M2PP-121-D-PLNM-0004

Site Specific Management Plan 004 - [sector 410/420]
MacKays to Peka Peka Expressway

01 SEPTEMBER 2014 - CERTIFIED ISSUE - REV C

SITE SPECIFIC MANAGEMENT PLAN - KAPITI MAZENGARB [SSMP 4 - SECTOR 410, 420]

CS2 - CROSS SECTION THROUGH CH 7800

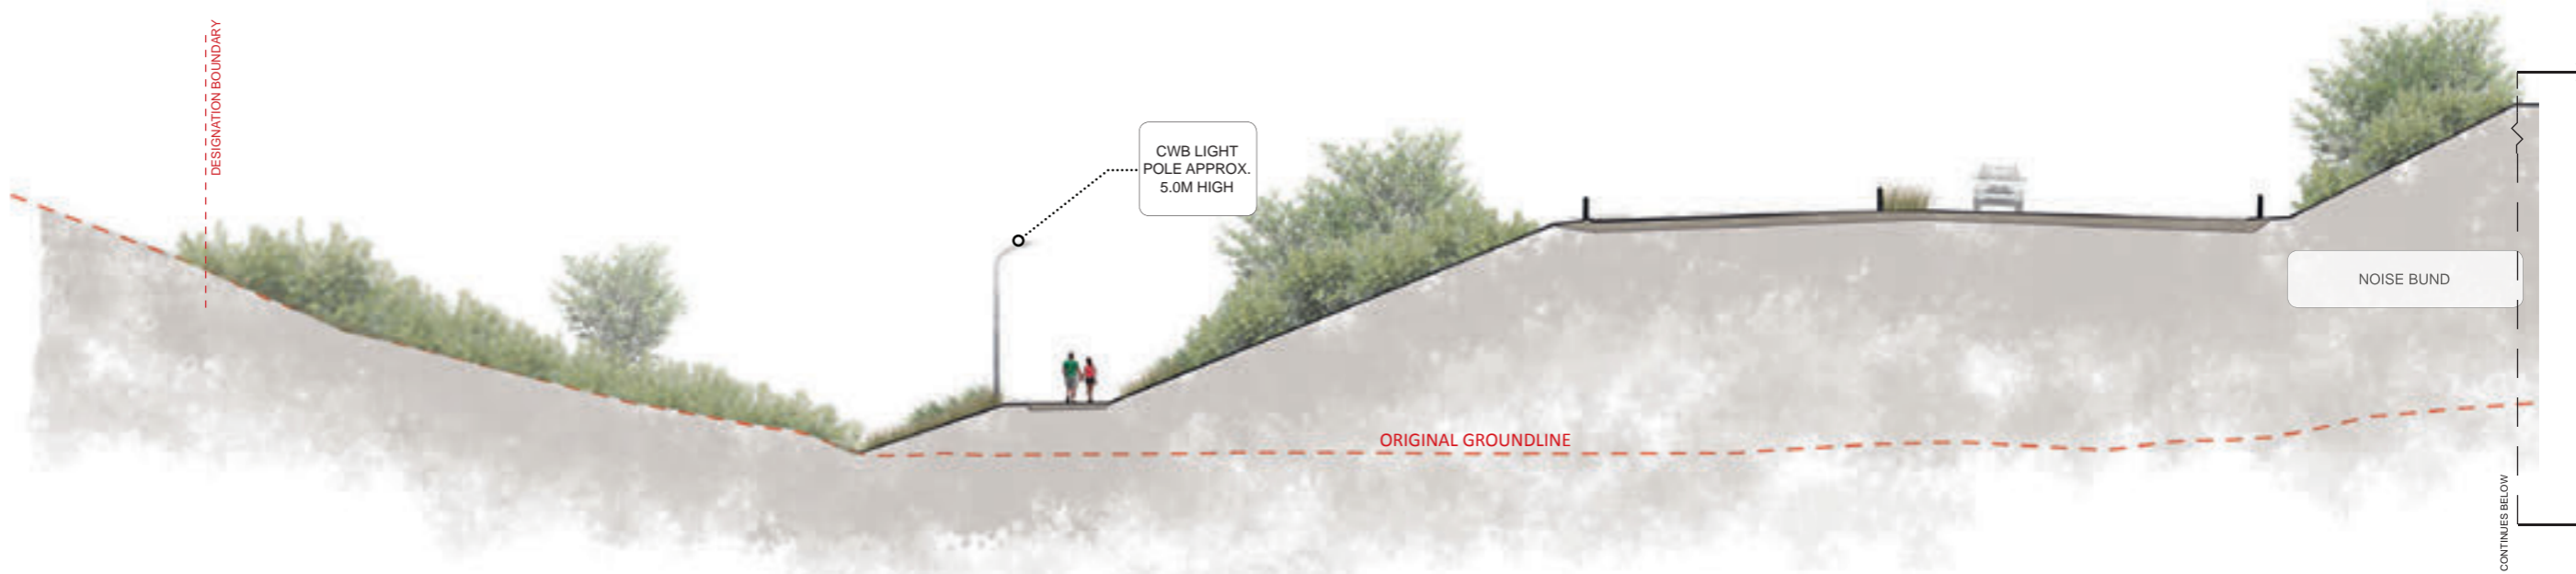
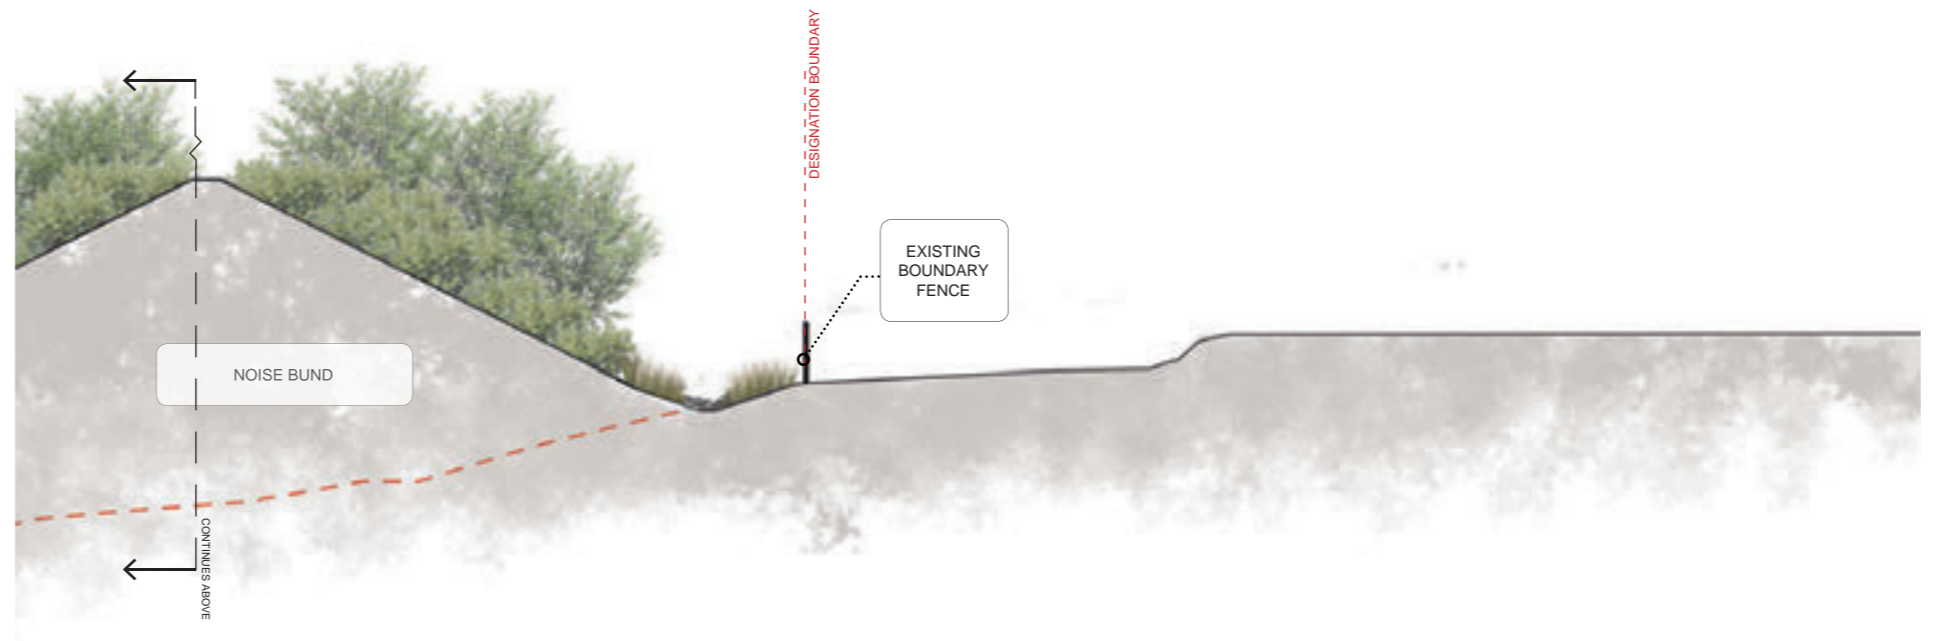
DC.59A g)	CWB detail	SK	Cross section through CH 7800; will the highway have a barrier on the western side to prevent vehicles from ending up on the CWB in an accident scenario?	SHEET 10 section	There are safety barriers along the whole length of the Expressway
DC.59A g)	CWB detail	SK	CS3 cross sectional elevation of Mazengarb bridge appears to show a 2m wide footpath on the north side and a 1.5m wide footpath on the south beside a garden area, is that correct? (Question relates to sheet 8 also)	SHEET 11 Bridge elevations	No. footpath on south of Mazengarb Road only. Proposed width 2200mm to tie into existing. Space provision has been made for future footpath on north side- currently there is no footpath to tie into.

Title: SSMP 4[410-420] - SHEET 9
MAZENGARB ROAD

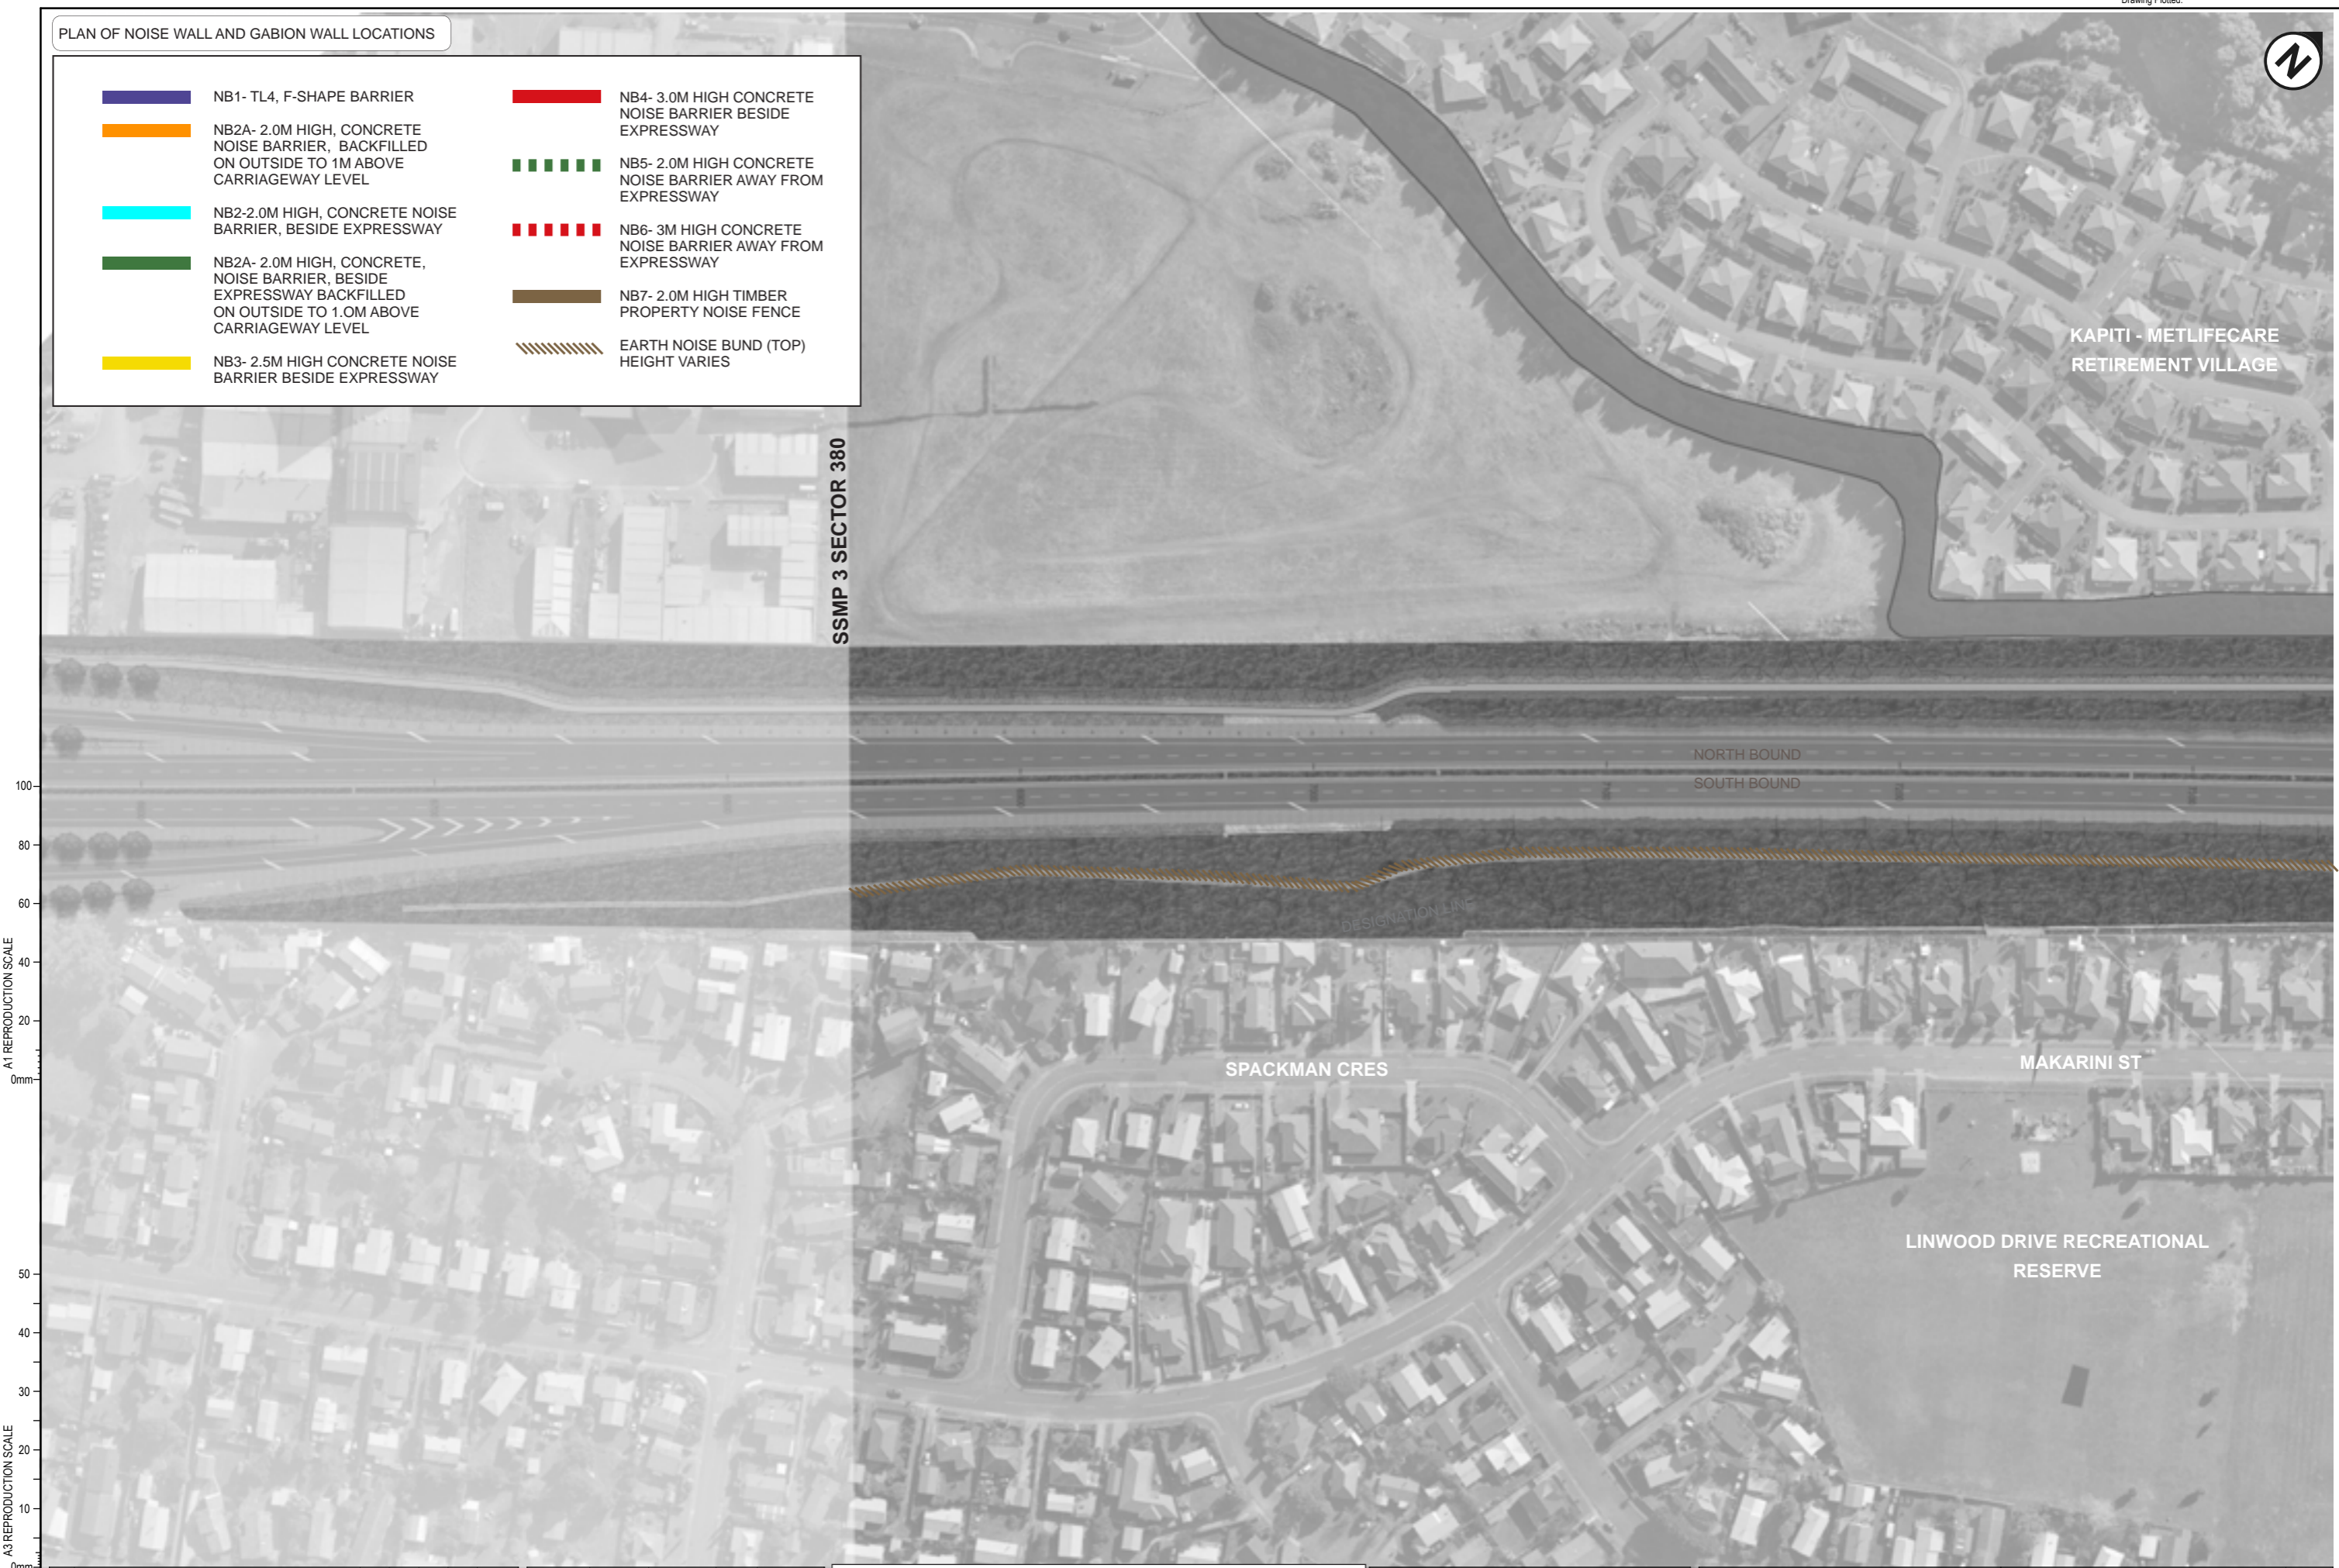
DC.59A g)	CWB detail	SK	Visualisation looks great although it doesn't show Mazengarb Road lowered and the difference in distance between the two CWB entries/exits to the abutments is not apparent.	SHEET 12 Mazengarb Road	Mazengarb Road has been lowered in the visualisation. The visualisation is intended to show the general appearance of the new bridge, detailed plans should be referred to as well.
DC.57A a) and b)	Maintenance along Makarini Street boundary	JW	Assumed that the maintenance track shown in the adjoining sector to the south in SSMP 3 would extend and run to Mazengarb Road. The swale (which is about 5.0m wide) could be also used for vehicle access for landscape maintenance. This would ensure that an eye would be kept on the boundary and thwart any incursion into the designation.	SHHETS 2 & 3	Maintenance access only needs to extend as far as shown on SSMP3 (ie to a sewer line manhole). The SSMP planting plans show swale planting extending between the end of the maintenance access and the swale; the SSMP and the planting plans are consistent with each other. The landscape constructor has confirmed that pedestrian access is only needed for vegetation establishment along the noise bund and this access will be along the unplanted top of the bund. The swale, which is a v-channel with riprap in the invert, could be straddled by vehicles if the swale was grassed but the series of scruffy domes along the length of the swale would be an obstacle to vehicles. A planted swale located adjacent to massed planting is consistent with planting design principles applied elsewhere. Additional maintenance width would require steepening the noise bund gradients beyond the standard.

AEE Consented to DET Proposed Graphic Comparison

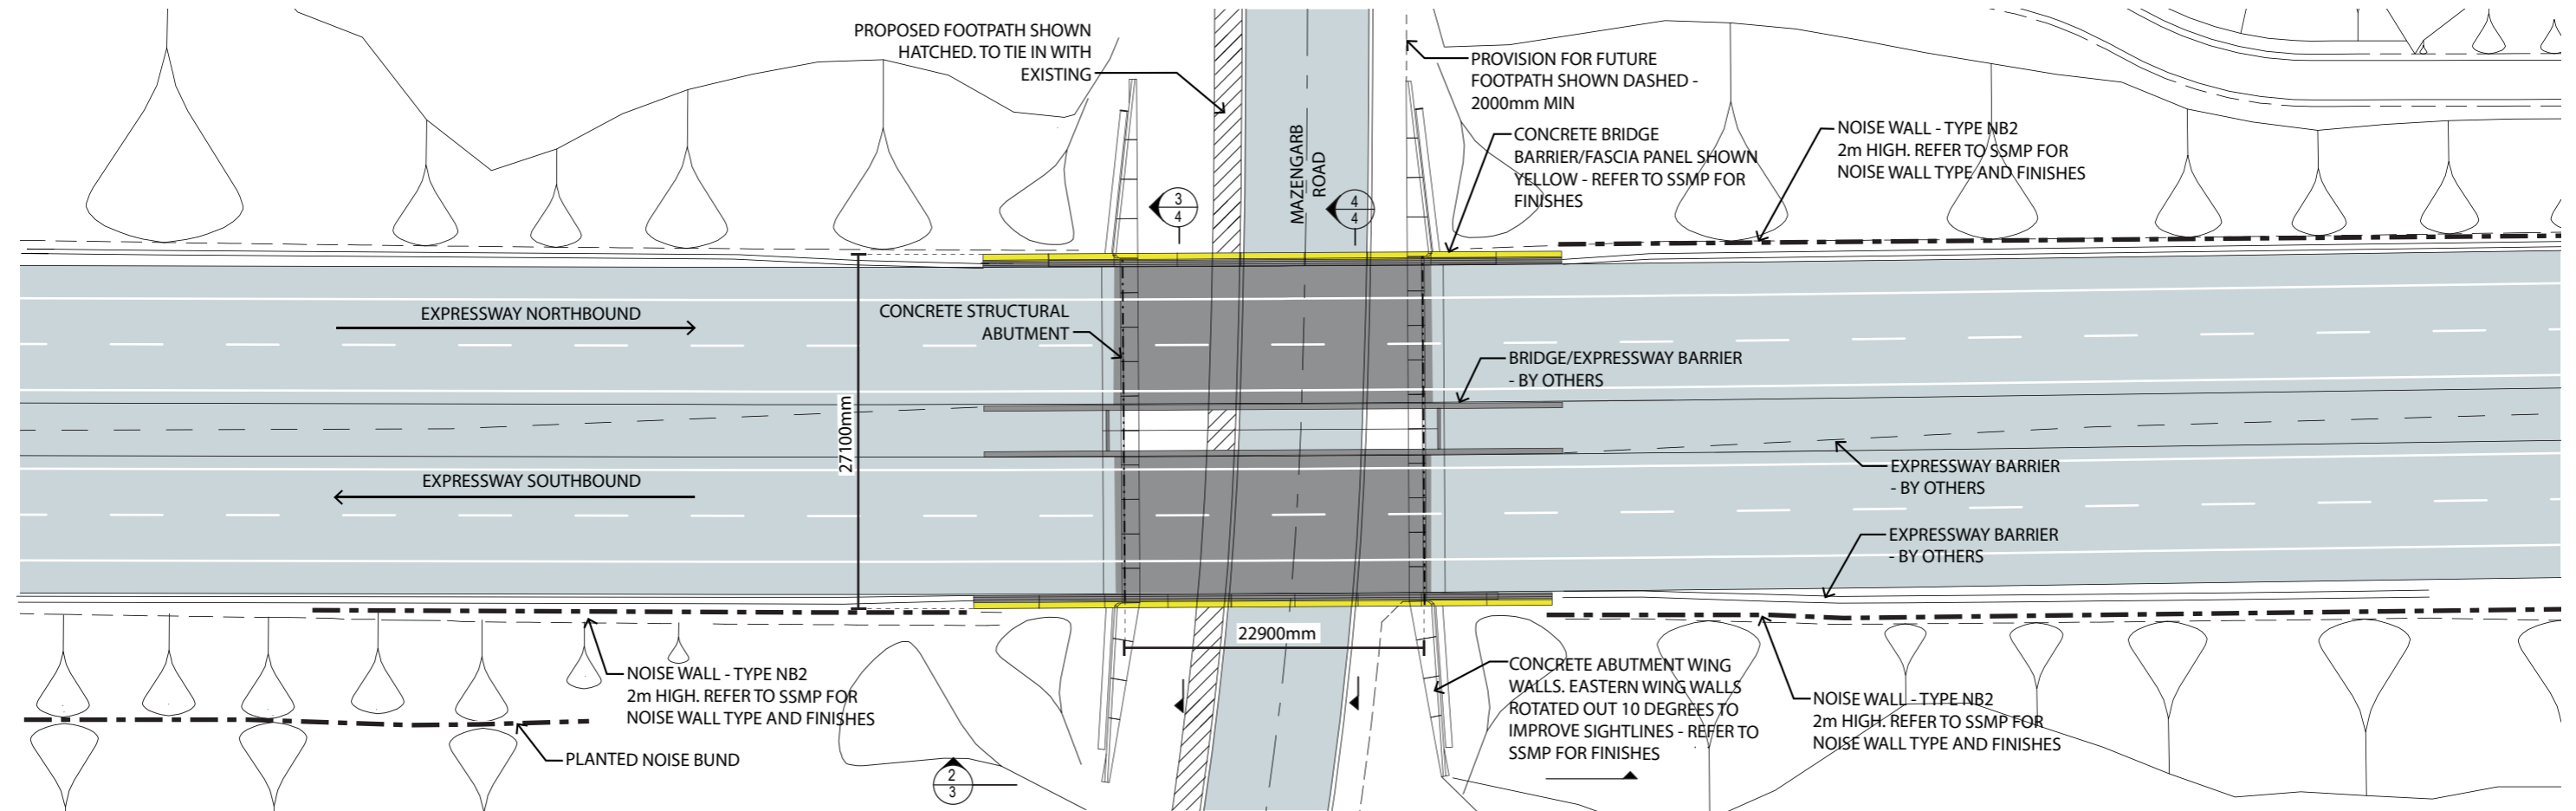
1. Improves constructibility
2. Lack of abutment information in AEE phase. The bridge abutments tie in with and retain the proposed embankments. The abutment wing walls are designed as one long continuous element, they lead pedestrians though and under the bridge connecting one side to the other.
3. Provided for reference only. Refer to SSMP for more detail and finishes
4. No existing footpath to tie in to on the northern side. Space provision for future footpath.
